July 19, 2019

ADDENDUM NUMBER TWO (2)

Project: Ridgeland City Hall
 City of Ridgeland
 PN: 14084

FROM: Dean and Dean/Associates Architects, P.A.
 4400 Old Canton Road, Suite 200
 Jackson, MS 39211
 (601) 939-7717

STAMPED CONCRETE PAVEMENT DETAIL
NOT TO SCALE

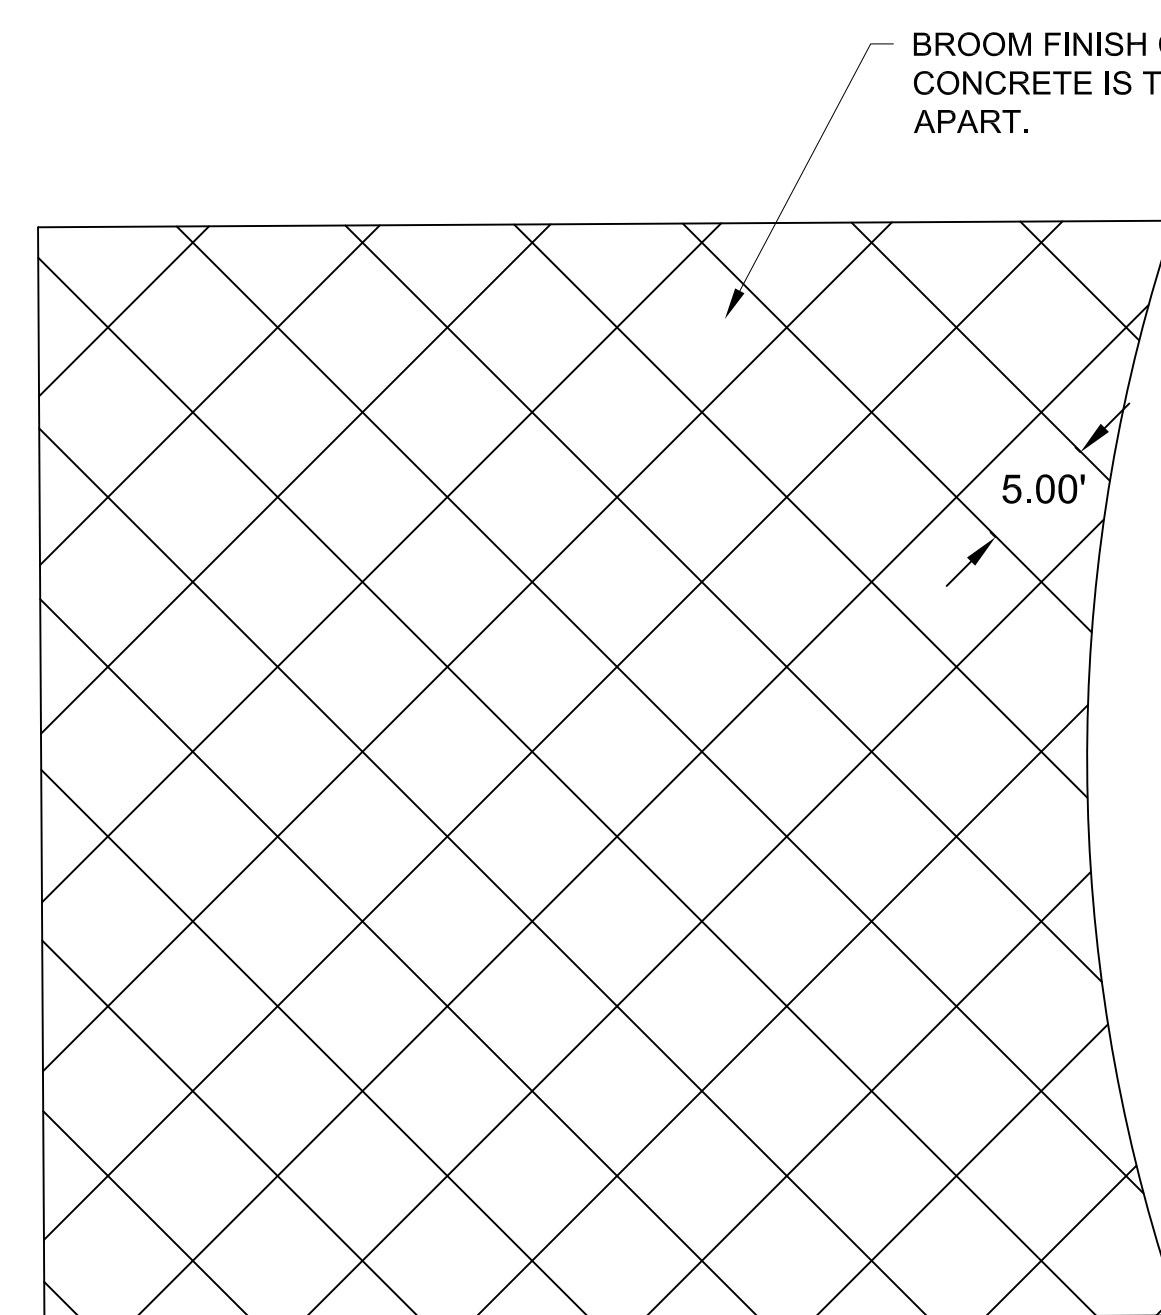
1. Detail C4: Updated Bomanite stamped concrete pattern and finish

NYLOPLAST DROP INLET DETAIL
NOT TO SCALE

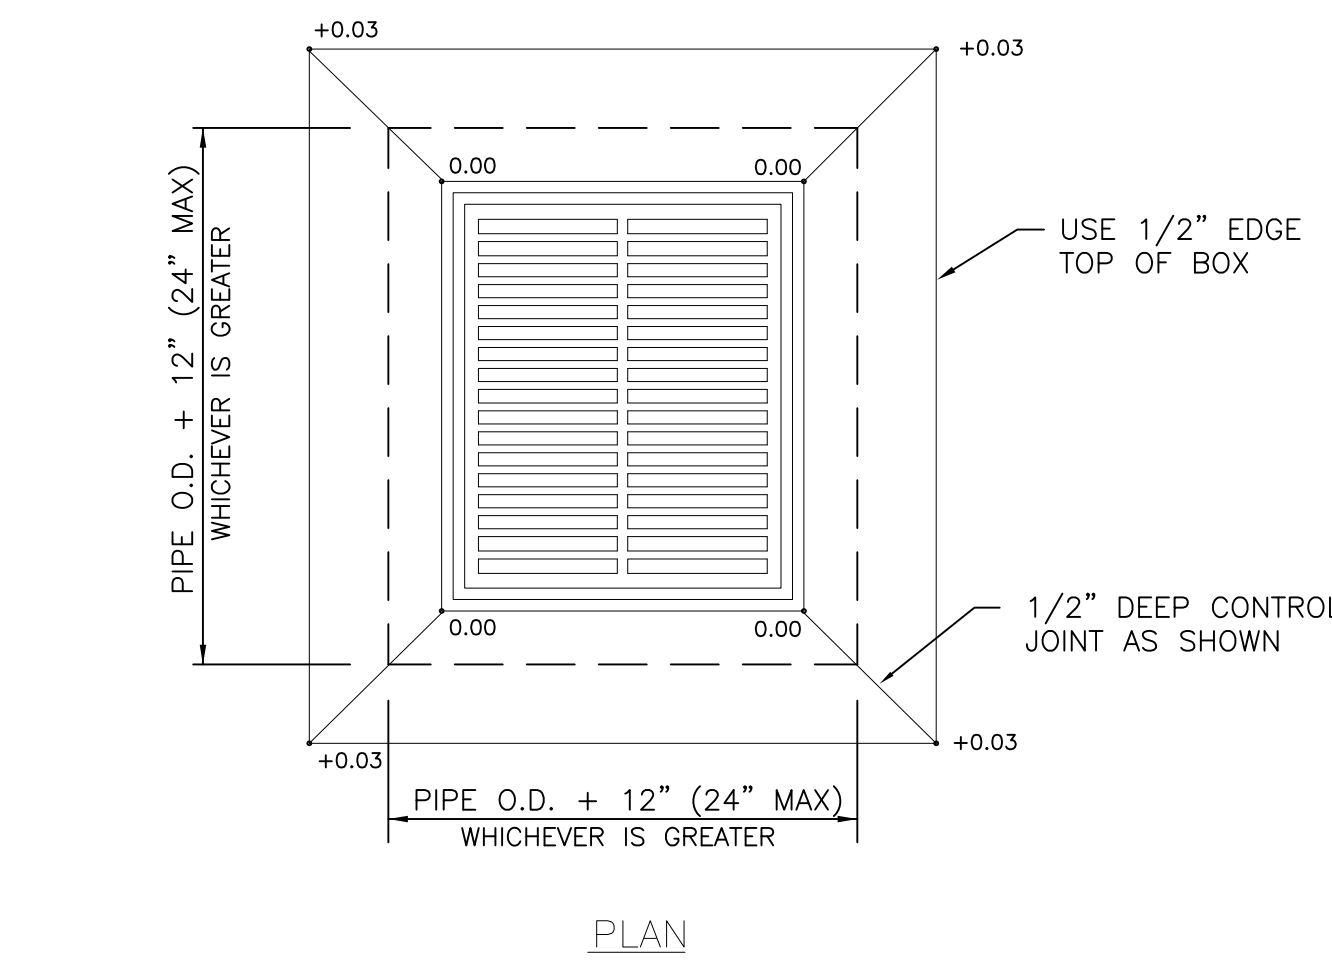
1. Detail C23: Nyloplast Drop Inlet detail was added
2. Detail C24: Detail was renamed to "Catch Basin Detail"

1 POLE BASE DETAIL
 E0.5 SCALE: NOT TO SCALE

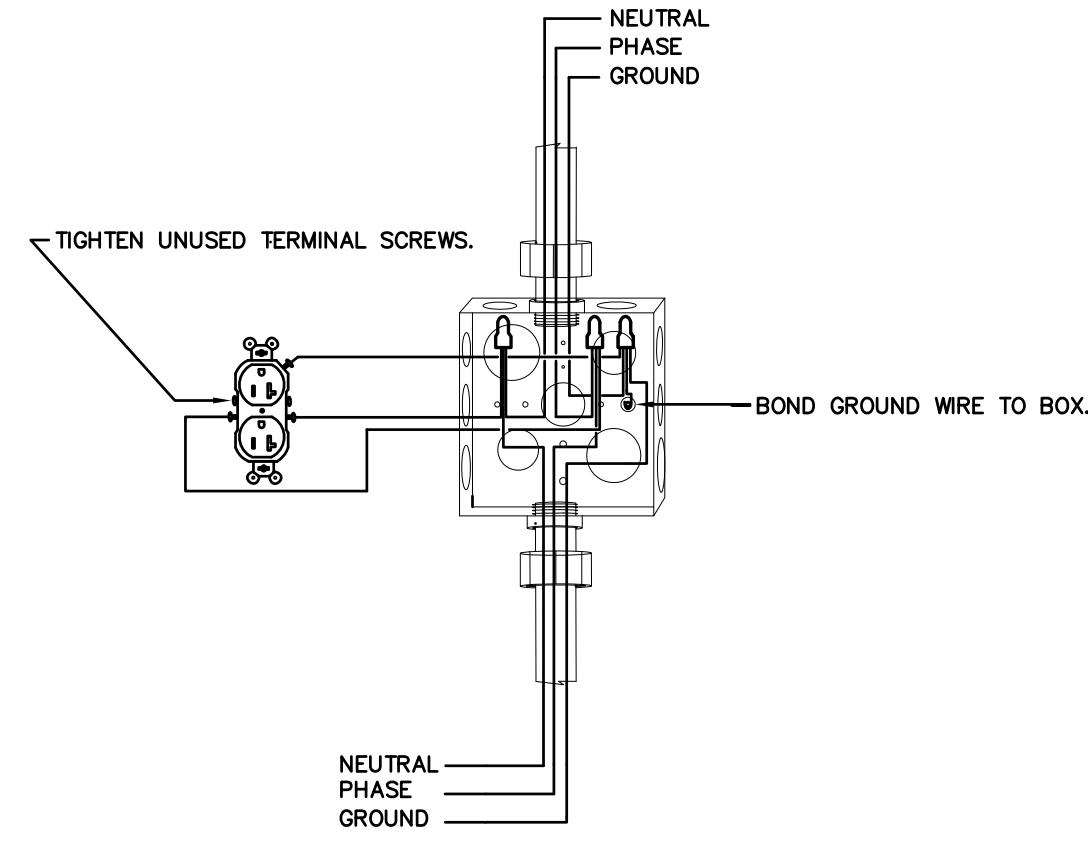
1. A pole base detail has been added for type SL4 fixtures.

1. A tamper switch for monitoring the post indicator valve has been added.
2. The Pole Bases for Fixture Types SL1A and SL1B shall be installed per Detail 1/Sheet E0.5 The Pole Bases for fixture Type SL4 shall be installed per new pole base detail

1 POWER RISER DIAGRAM
E.O.6 SCALE: NOT TO SCALE

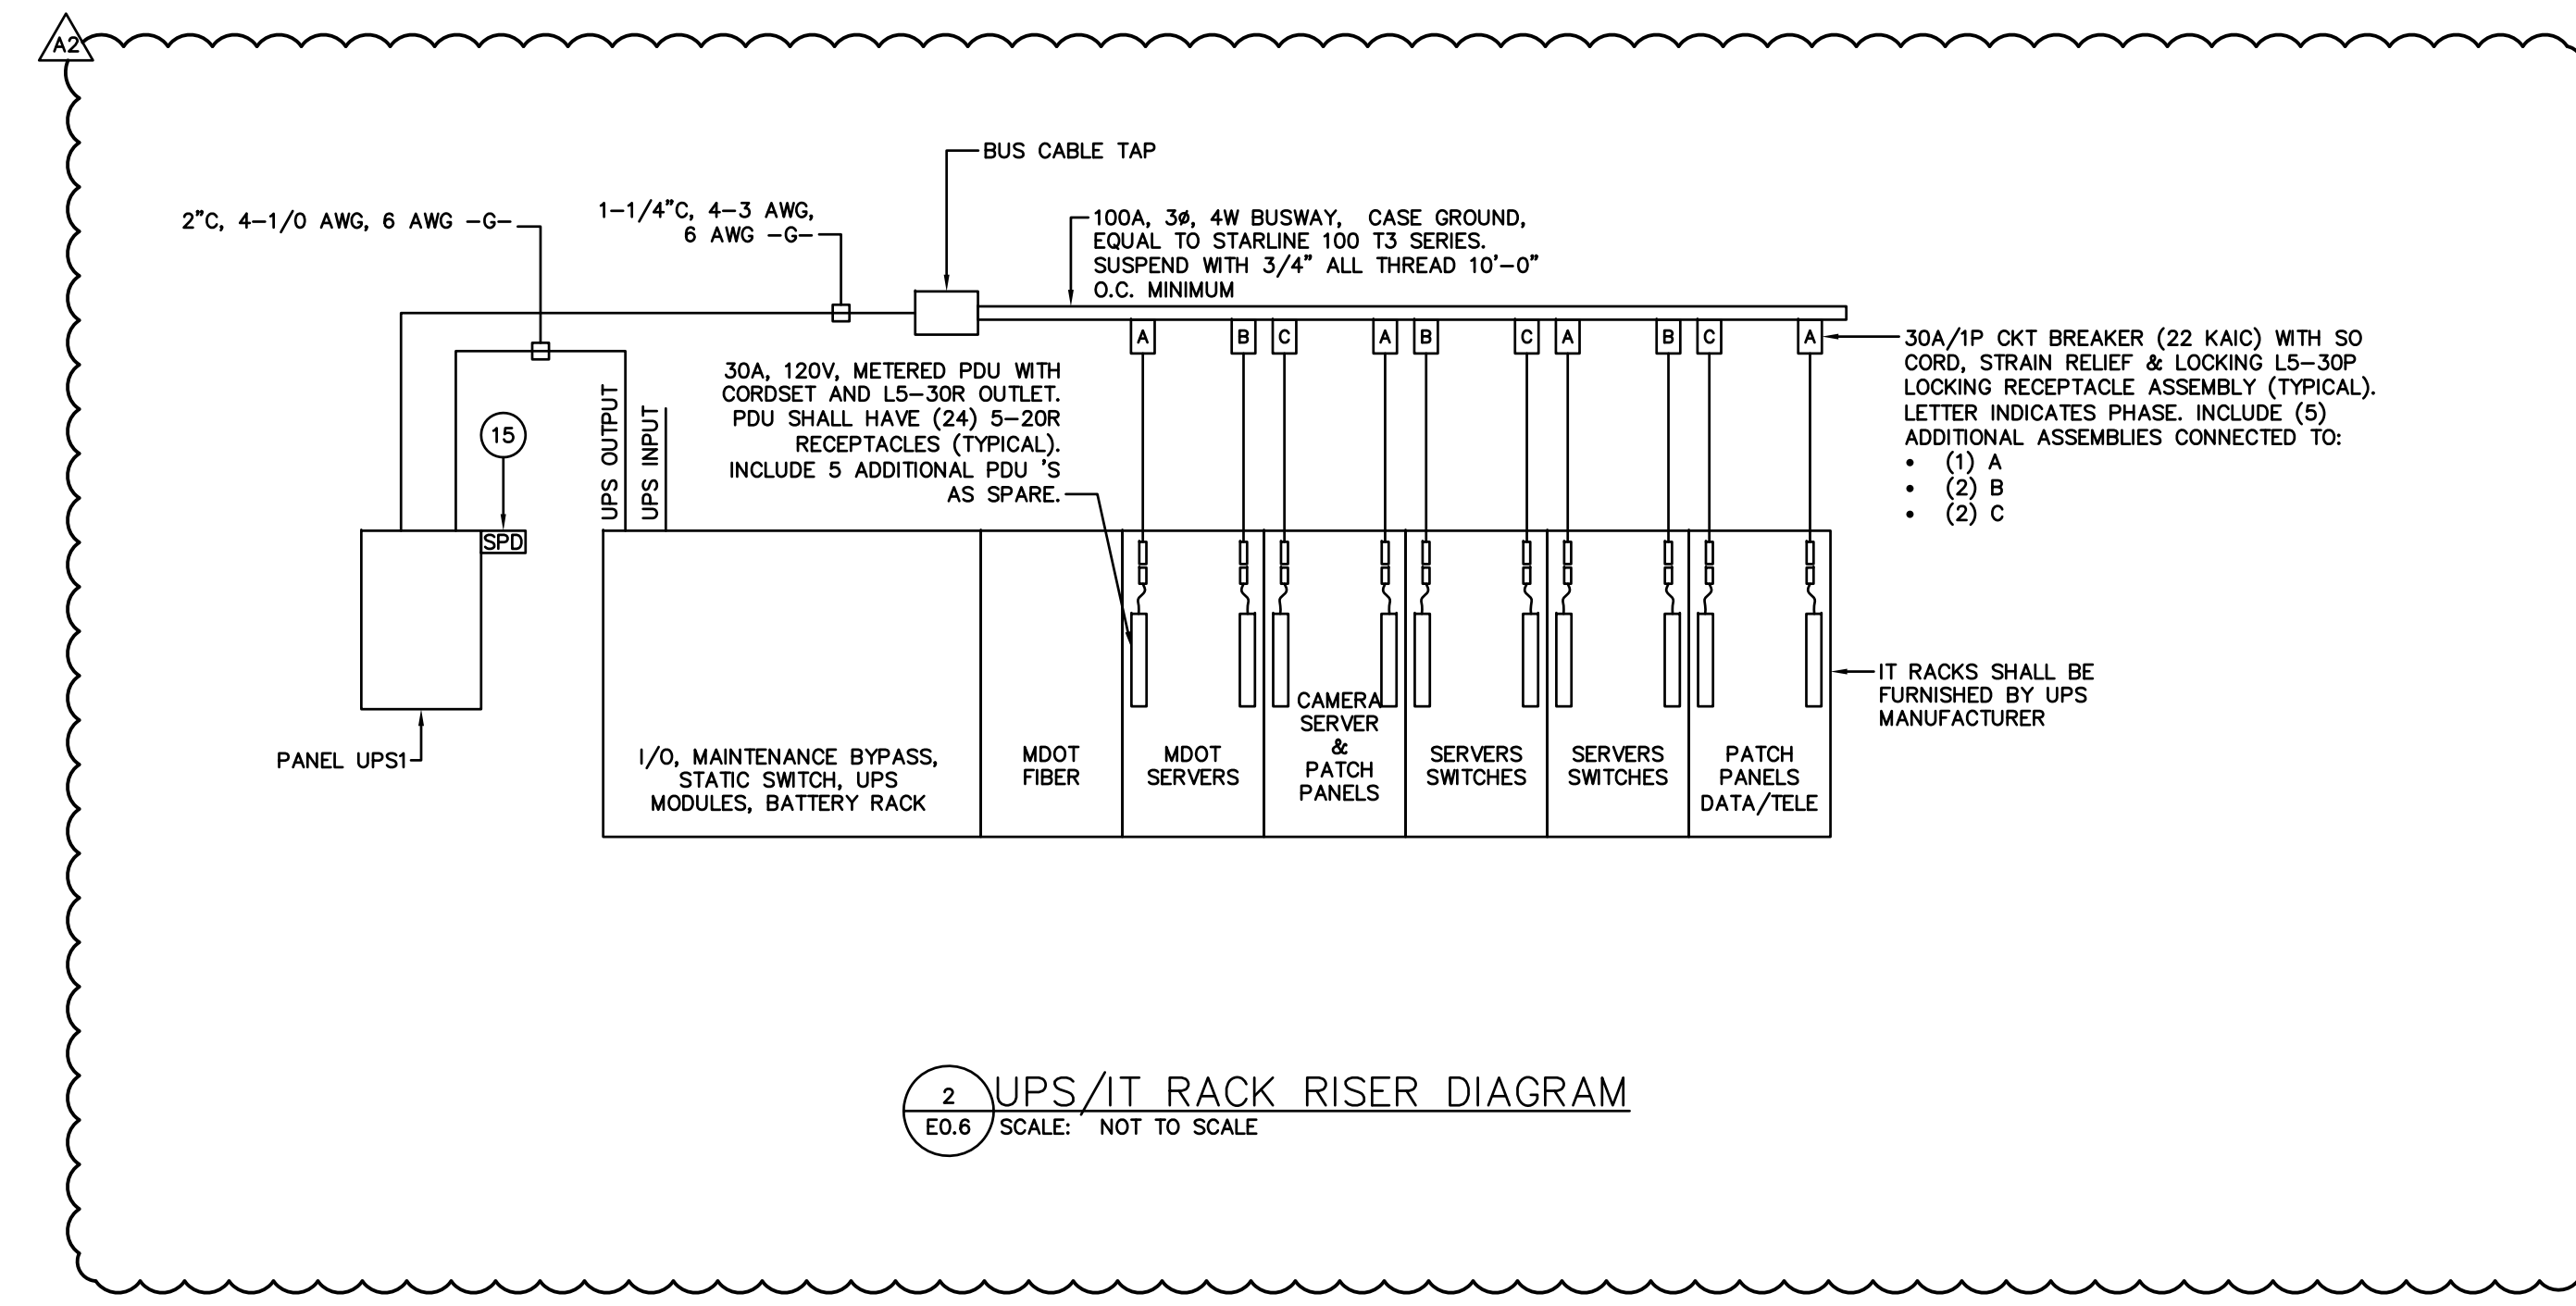
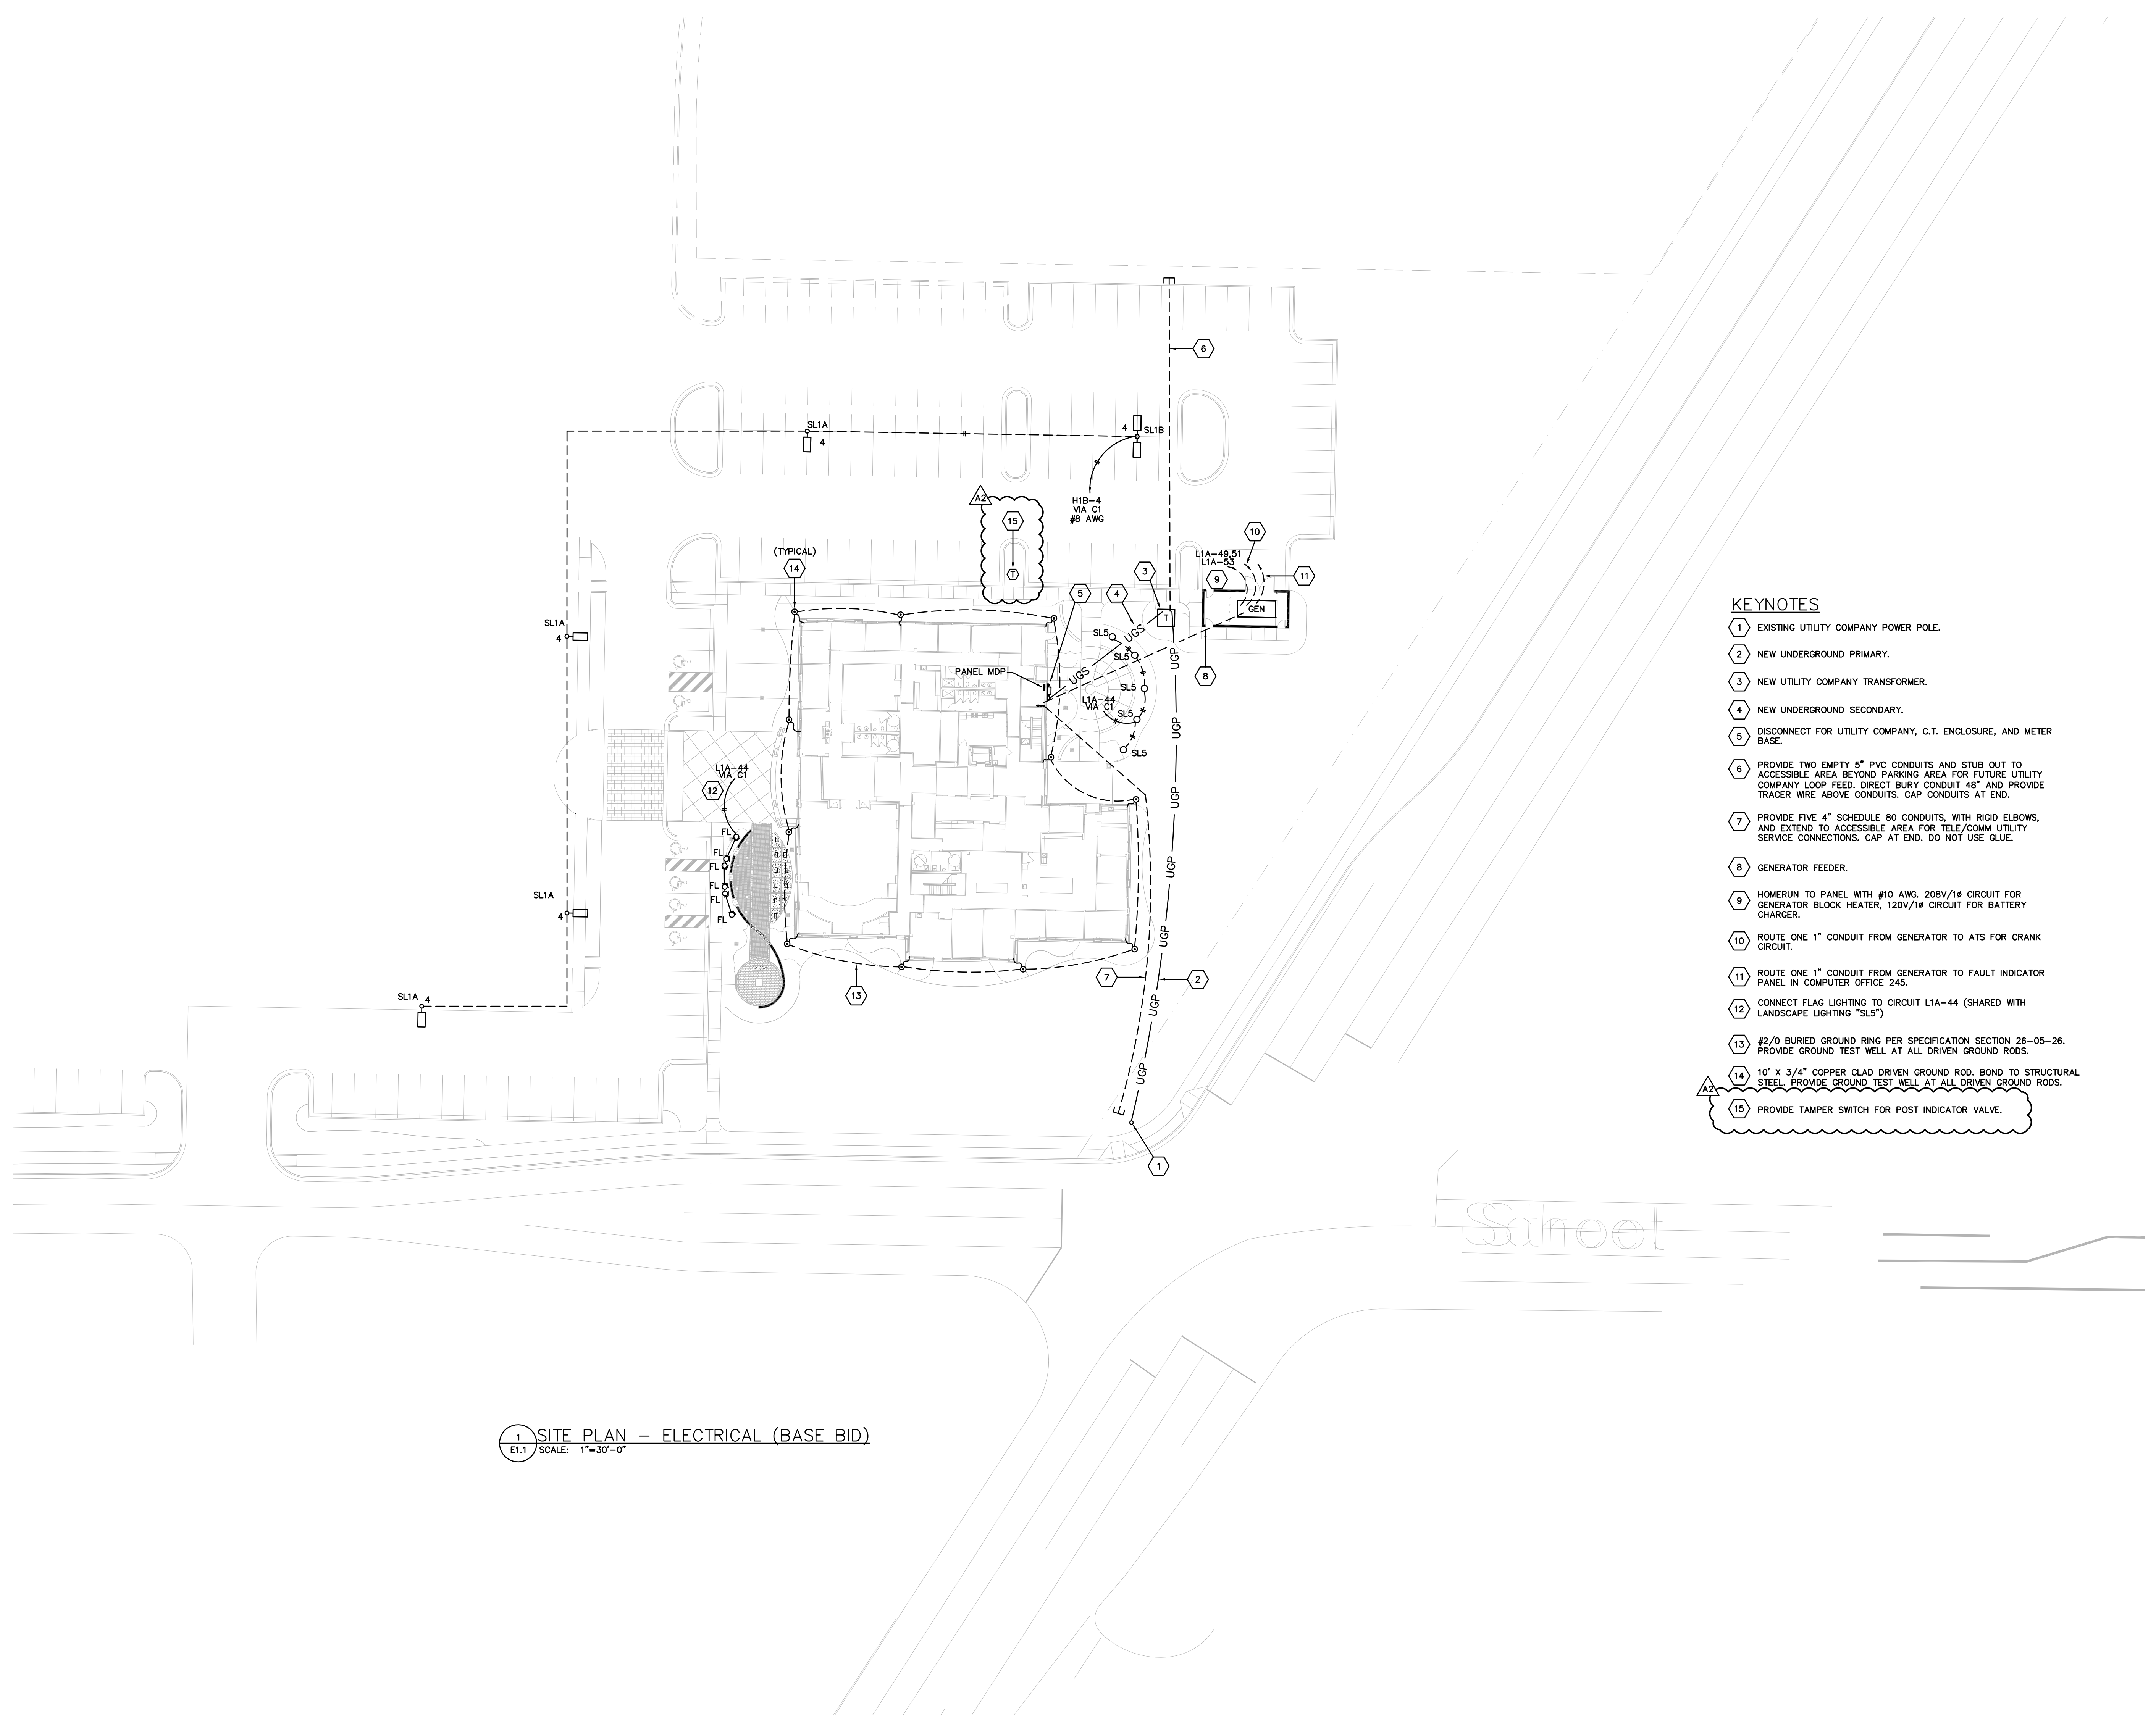
1. Keynote 11 serving T-UPS shall change to Keynote 16. Feeder shall be 3-#4, 1-#8(G), 1-1/4" C.
2. Keynote 12 serving the UPS shall change to Keynote 17. Feeder shall be 4-#1/0, 1-#6(G), 2" C.
3. The UPS/IT Riser Rack Detail has been added.
